**SR-2 – ADVISORY STAFF REPORT (04-07-2026)**

**ADDRESS:** 1000 ST. ANNE AND 2635 W LAFAYETTE

**APPLICATION NUMBER:** HDC2026-00107

**South wall of the Chapel has pointed-arch windows. The north wall of the Chapel has no windows because it abuts the rest of the Church building to the north. Note lack of trim at wall around window openings. Photo by staff**

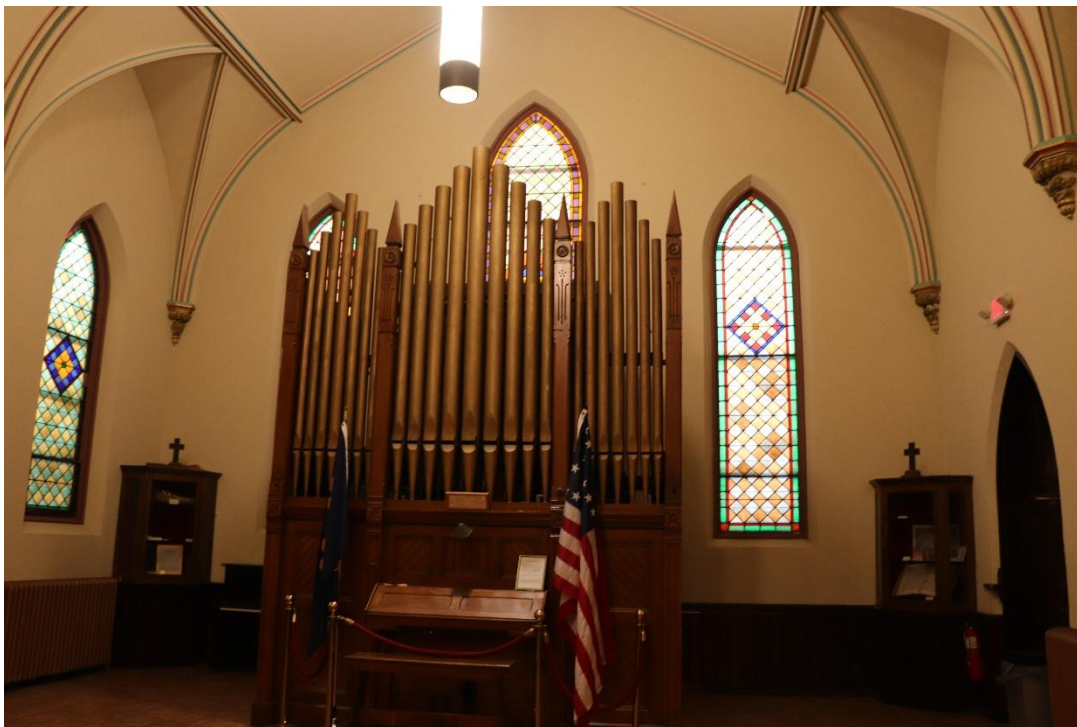
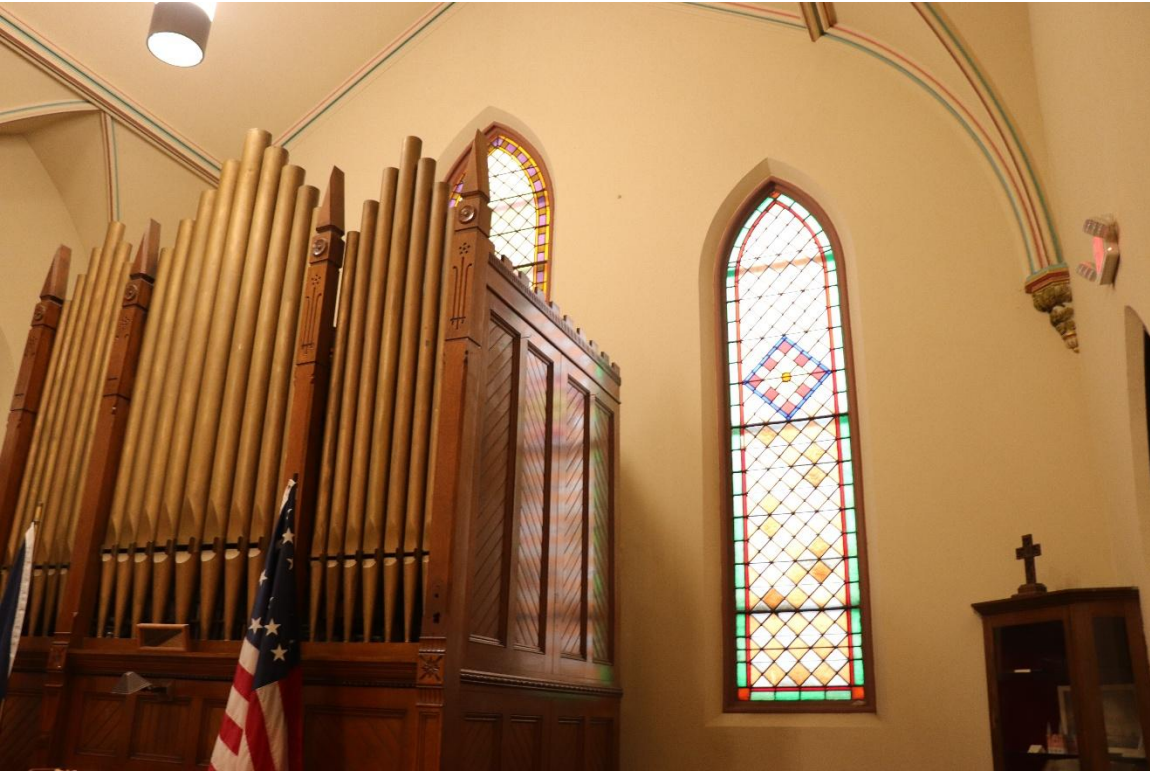
- Within churches/basilicas, chapels are traditionally smaller, more intimate spaces meant to accommodate quiet repose, personal reflection, and small religious services. As such, a chapel's interior detailing is typically subordinate to that of the church's main interior space. The chapel's current unadorned white walls and ceilings, window and door surrounds, wood wainscoting, and light fixtures are distinctive, character-defining features which should be retained because they function to reinforce a more subdued esthetic when compared to the main church's more ornate detailing. The project proposes elaborate elements that largely mimic detailing found within the main church's interior, which would disrupt the historic visual relationship between the two spaces. As the chapel space was intentionally included in the interior designation, it is staff's opinion that this relationship is one that is distinctive and character-defining and therefore must be maintained.

- The proposed new wainscoting, ceiling paint, window and door trim, panel trim, and light fixtures are conjectural features/architectural elements that could be mistaken as original or historic elements, which does not align with the Standards.

- Finally, Element of Design #10 notes that "detail of the other buildings conform to their styles and types." This Element specifically emphasizes the importance of the stylistic diversity of the buildings within the complex. Attempting to muddy the character of district buildings and spaces by introducing features from others is inconsistent with this.

1. With respect to the chapel wing of the basilica, its current unadorned white walls and ceilings, window and door surrounds, wood wainscoting, and light fixtures are distinctive, character-defining features which should be retained in order to retain its subordination to the church's main interior space and its subdued character. The proposed new elements largely mimic detailing found within the main church's interior, which would disrupt the historic visual relationship between the two spaces. The new elements are conjectural and could also be mistaken as original to the building

Google Streetview image. Three windows at basilica proposed for replacement, outlined in yellow

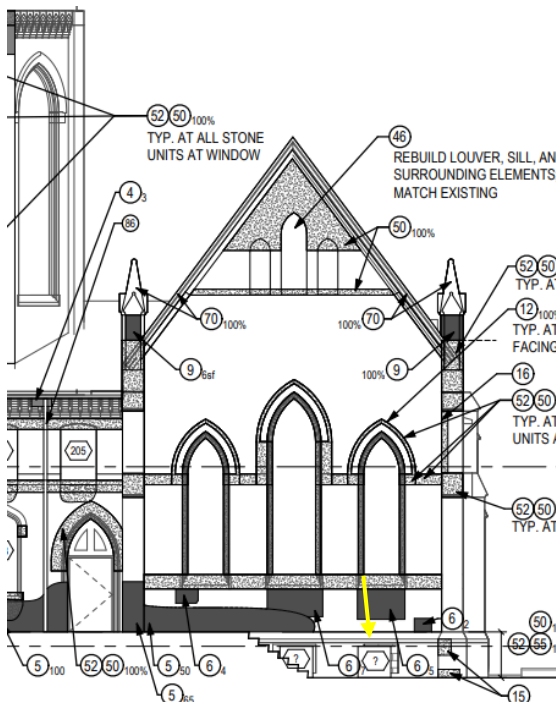
- The application notes that they are wood, display wood tracery, and are visible from public sidewalk/street. The application further states that the windows are in non-repairable condition and is therefore proposing and in-kind replacement. Staff notes that the submission only includes one photos to represent the condition of the three windows proposed for replacement and therefore concludes that the submission does not provide the level of information necessary to demonstrate that the units are deteriorated beyond repair. Also, the application does not provide dimensioned drawings of typical existing conditions at these historic windows and the proposed new units so that staff can ascertain if the replacement windows would adequately match the existing. Staff therefore cannot recommend approval of this scope item.

2. The submission does not include the level of documentation necessary to substantiate that the three historic wood windows at the second floor, 2-story portion of basilica (sacristy) which are proposed for replacement are deteriorated beyond repair. Also, the application does not demonstrate that the proposed replacement windows are an adequate match for the existing historic units as drawings of typical existing conditions and the proposed new replacement units have not been provided

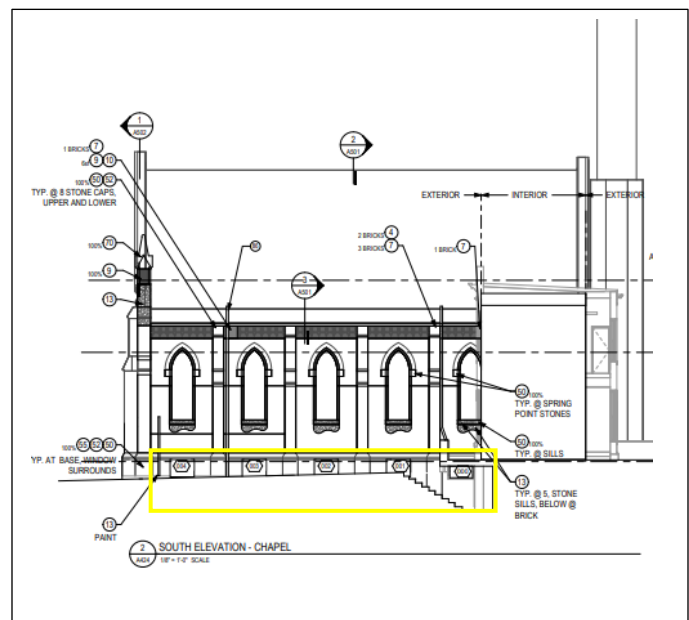
- One of the window openings is proposed for infill with masonry (4” rusticated face stone w/ CMU backup) recessed to maintain visual reading of the masonry opening is in a highly visible location at the west façade of the chapel wing (see below). It is currently enclosed with an incompatible plywood panel (window 005). The proposed treatment for this window is not recommended by staff because the window opening is in a conspicuous location of the

building and the work would continue the incompatible opaque enclosure/infill of the character-defining opening. Also, per Element of Design #8. *Relationships of Texture*, “the glazing on all buildings, especially the church, provides a contrasting smooth surface. The scope item does not conform to Element #8.

3. The proposed infill of basement window openings at the Rectory, Basilica/church building, and Convent/Wellness Center will detract from the distinctive, character-defining expression of the each of the building's historic fenestration openings within the foundation wall.

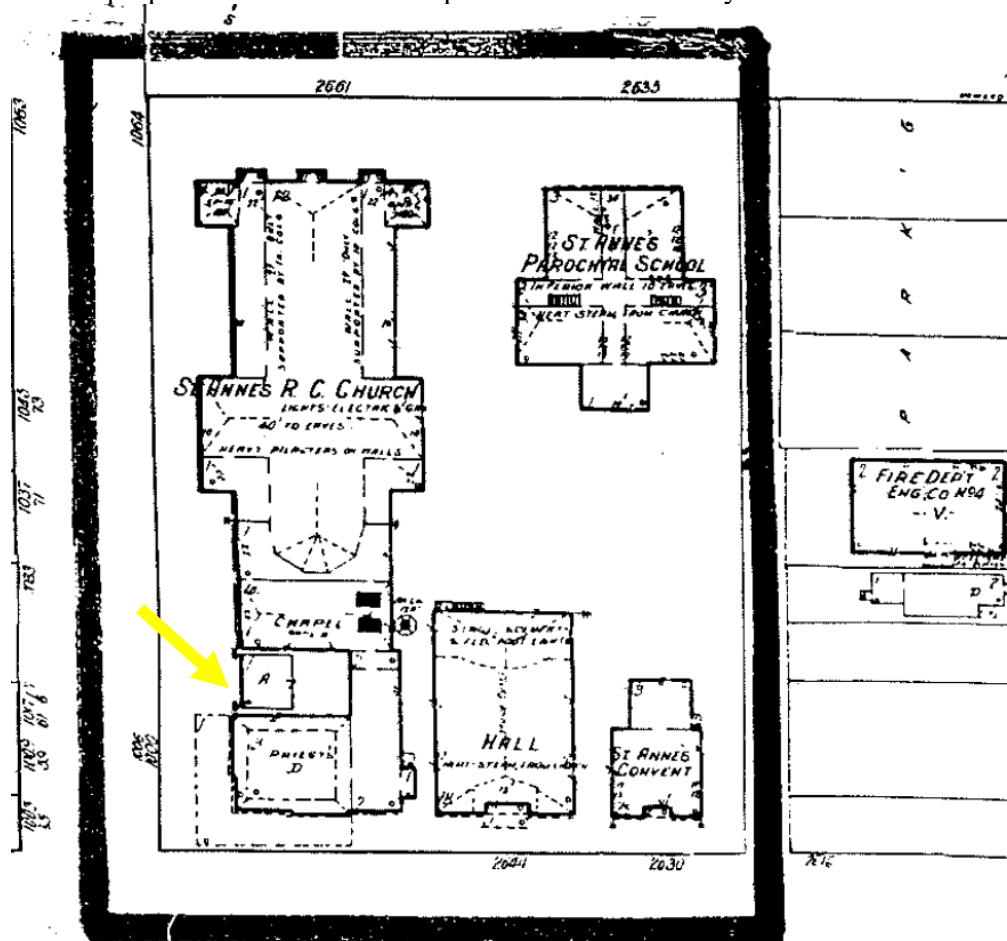
- With respect to the garage’s significance, note that the HDAB designation report [Ste. Anne's Parish Complex HD Final Report.pdf](#) clearly states that “...all structures within the boundaries contribute to the historical and/or architectural character of the district.” The report also briefly references the garage, stating that it is located “...between the chapel and rectory” and is a “...two-car garage of tapestry brick and trim.” The below map, excerpted from the designation report, outlines the district boundaries and the footprints of the buildings located within, to include the garage. The garage is contributing to the district as it is located within the district’s boundaries, it retains its integrity of location, setting, design, materials, workmanship, feeling and association to a good degree, and it does not appear to be deteriorated to an extent that merits its demolition. It is therefore staff’s opinion that its proposed demolition and replacement with a courtyard does not meet the Standards.

- It is staff’s opinion that the garage plays a role in the wall of continuity along Ste Anne Street (see the below photo) and that it does display architectural ornamentation “typical of a building of a public character.” Therefore, its removal would not conform to the district’s Elements of Design

4. The garage proposed for demolition contributes to the district
5. The submitted documentation of the Rectory's and Parish Hall's distinctive, historic character-defining wood windows which are proposed for replacement do not adequately establish that they are deteriorated beyond repair. Also, the application does not demonstrate that the proposed replacement windows are an adequate match for the existing historic units as drawings of typical existing conditions and the proposed new replacement units have not been provided

The rear of the Parish Hall, showing the enclosed staircase proposed for removal (yellow arrow). Staff does not find the enclosed staircase to be historic or character defining and does not object to its removal. (Staff photo, November 2025)

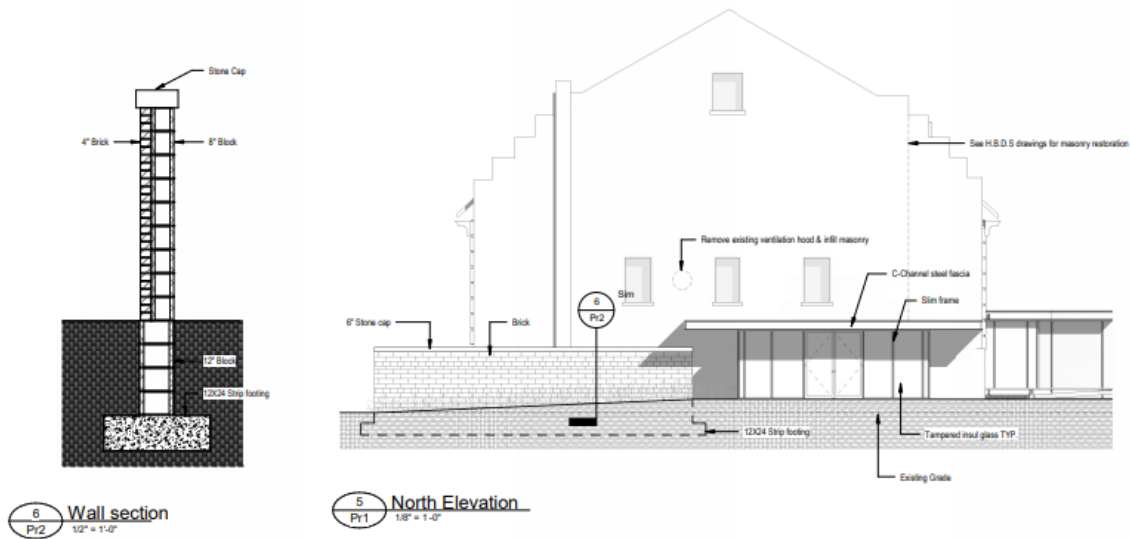
- Demolish rear stair enclosure and shed addition near northeast corner (see below). Staff does not find that these two additions are historic or character-defining and therefore supports their removal as they detract from the building's historic character.

From applicant materials, LB1, custom lattice design will reflect liturgical theme

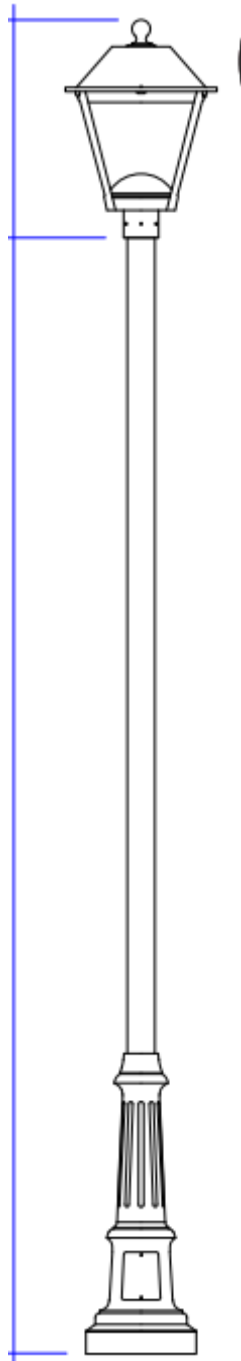
- It is staff's opinion that the proposed work is compatible with the site as no historic features will be altered or removed and the property's historic character will not diminished by the proposed new elements.
